UNITED STATES PATENT AND TRADEMARK OFFICE

10/803,512

Office Action Summary	Application No. 10/803,512	Applicant(s) ROME, GUY	
	Examiner QUYNH-NHU H. VU	Art Unit 3763

DETAILED ACTION***Response to Amendment***

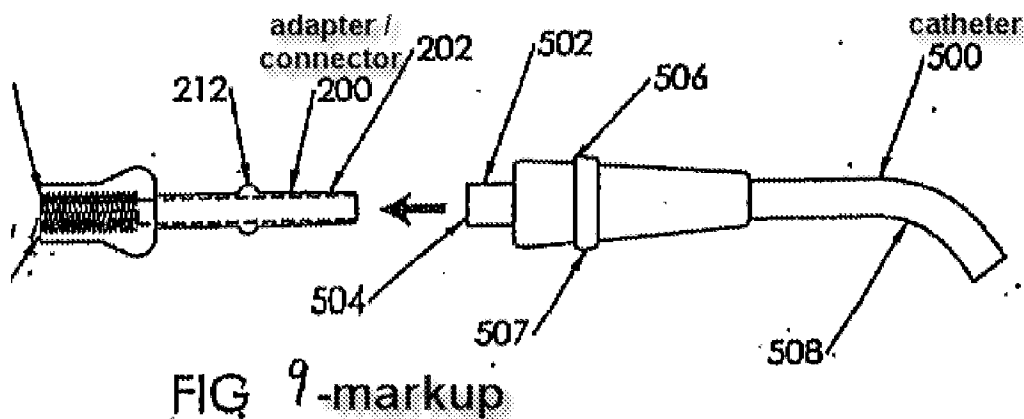
Regarding claims 30 and 44-45, Canaud discloses a catheter assembly in Fig. 9 comprising: a catheter 500 including at least one lumen; a connector/adaptor 200 (Figs. 2 and 9) or 270 (Fig. 3, note that the adaptor 270 is generally includes similar features of the adaptor 200 shown in Fig. 2, see para [0042]) including a distal end 202 attached to a proximal end 502 of the catheter and a passageway 206 (Fig. 2) or 278 (Fig. 3) in fluid communication with the at least one lumen 504, see Figs. 9-10; a proximal portion of the passageway including an engagement feature (i.e. element 208 having a thread connection

214 (Fig. 2), 286 (Fig. 3)) configured to connect an end of an instrument (i.e. tulener 300 or a port 400, see Fig. 1) to the connector 200 or 270; a distal portion of the passageway 278 including a valve 272 longitudinal fixed (firmly in position) with respect to the connector 270. Canaud further discloses that other types of valve (i.e. duck valve or slit valve) may be used in the adapter 270, see para [0043], therefore, one of examples of the type of duckbill valve 424 in Fig. 7 can be used in the adapted 270; wherein the valve having a closed proximal end with a slit (as well-known in the duckbill valve art) and open distal end, (see valve 424 of Fig. 7) and the proximal end of valve 272 distal of the engagement feature 286.

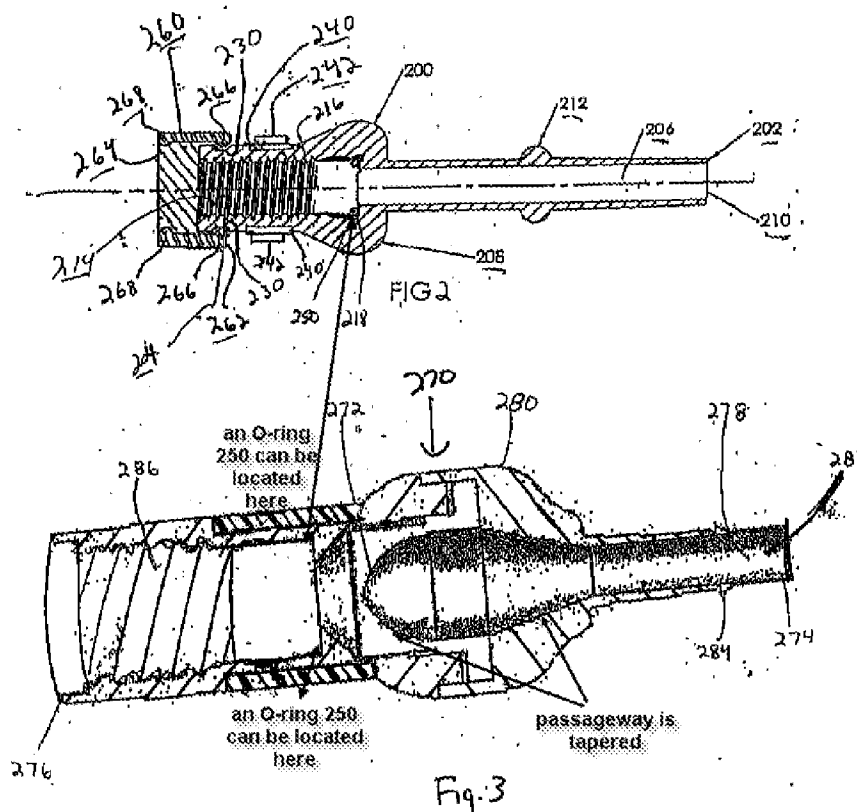
Regarding claim 31, note that the valve includes a wall defining a lumen from the proximal end to the distal end, the wall configured to or (adapted to/capable of) to guide a proximal end of a guide-wire from the valve distal end through the slit in the valve proximal end.
